DULUTH UNION DEPOT AND TRANSFER COMPANY
~~NORTHERN PACIFIC RAILWAY COMPANY~~

AUTHORITY FOR EXPENDITURE 1926 YEAR 1926

Location: Sixth Avenue Viaduct, Duluth.

Title: Replace two stone piers with steel columns.

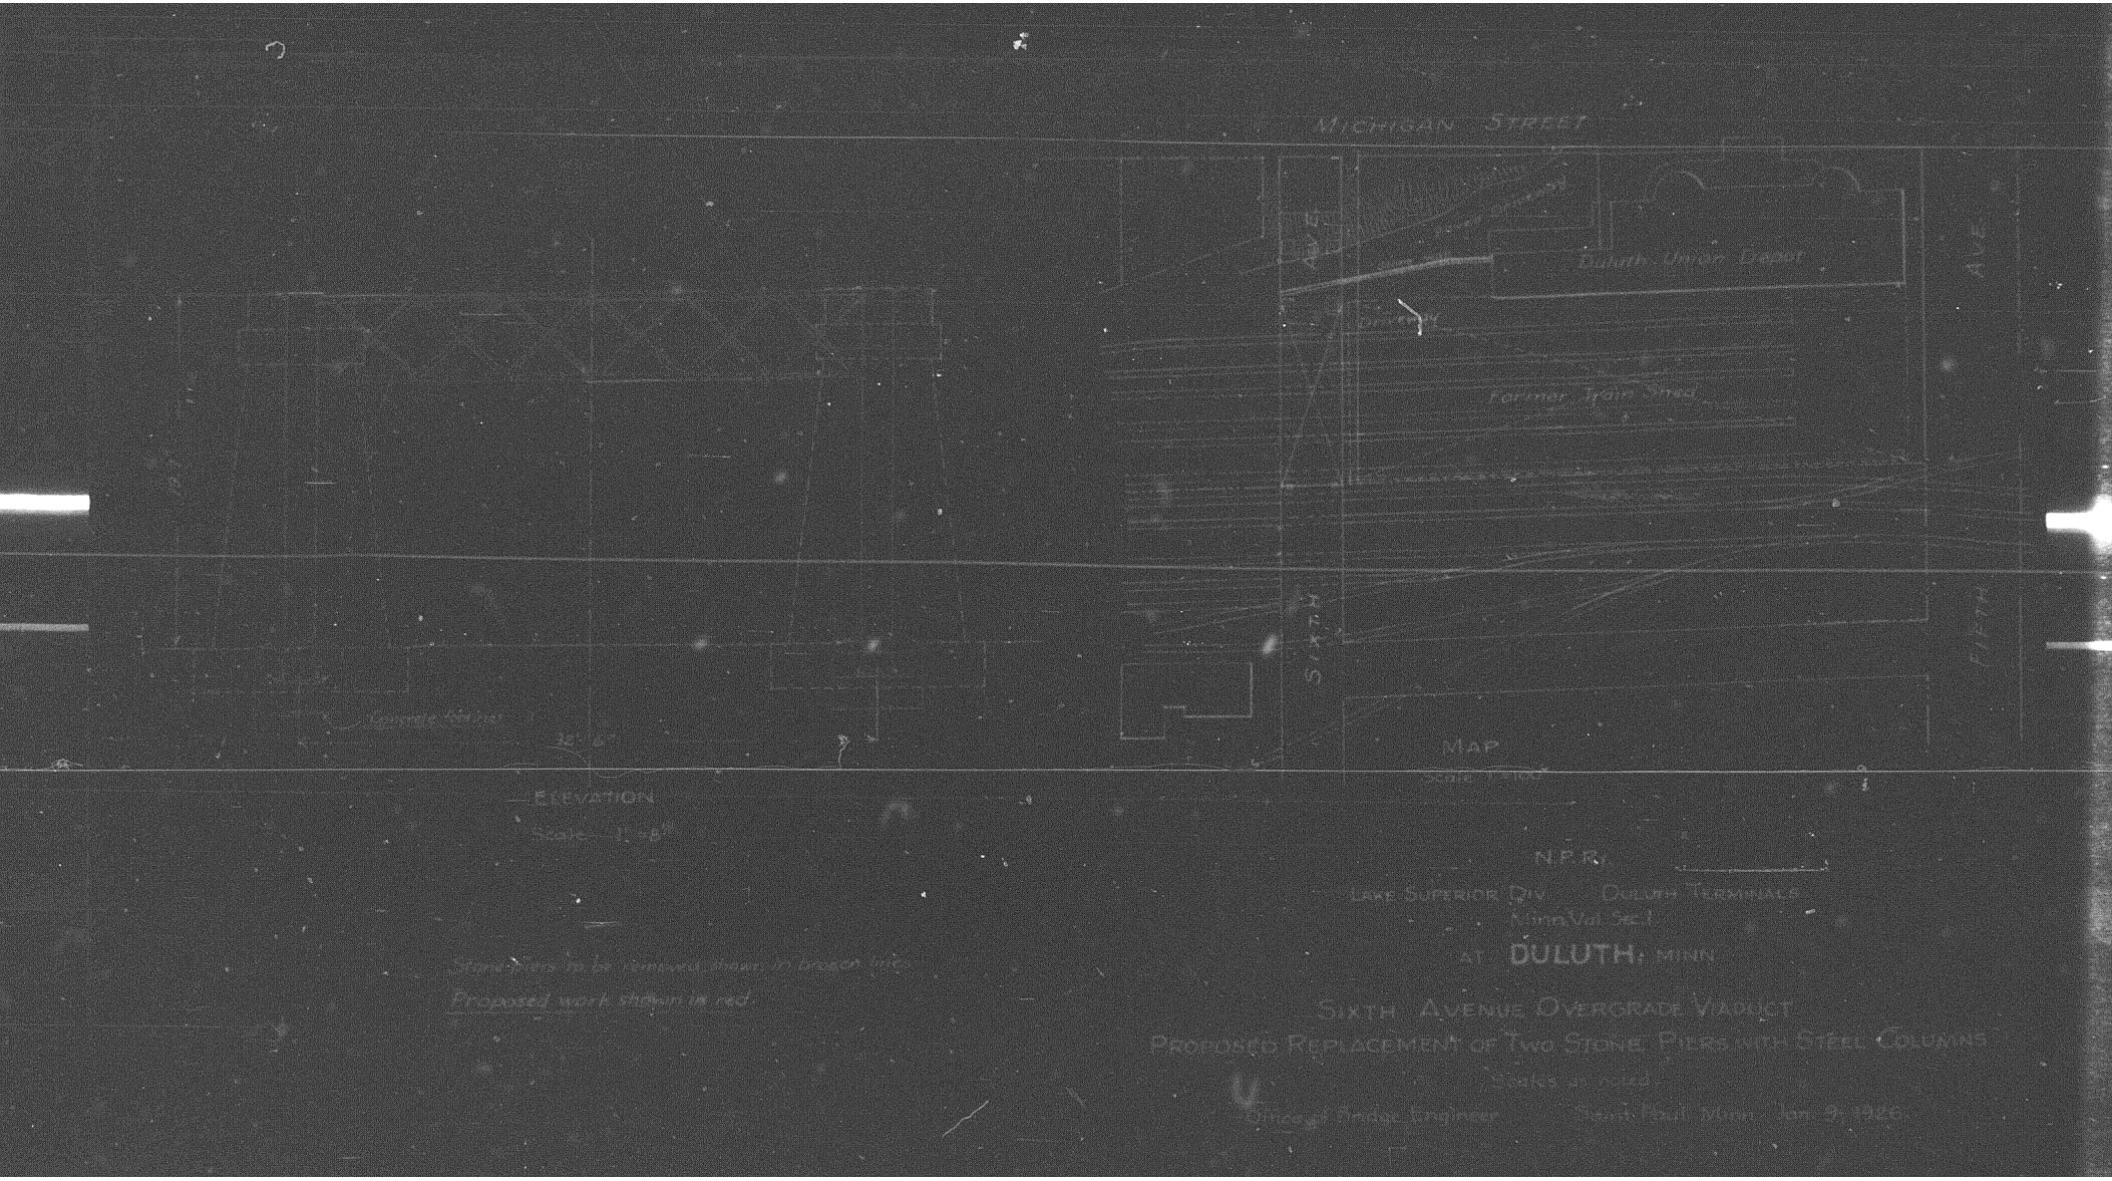
Reason: The viaduct is adjacent to the west end of the Duluth Union Depot and the space under the north end of the viaduct is used as a driveway to reach the express and mail rooms. Before the removal of the train shed the driveway had been extended by planking between the rails of the most northerly track. With the removal of the train shed and the construction of the present covered platforms, it became necessary to remove the planking between the rails and discontinue the use of this portion of the driveway, resulting in restriction of the area of the drive, so that it is now congested and there is not proper room for the handling of trucks.

There are two masonry piers supporting the viaduct, located in the driveway. These are ten feet square. It is proposed to increase the clearance and thus relieve the congestion by removing the piers and substitute two steel columns which will occupy a space about two feet square.
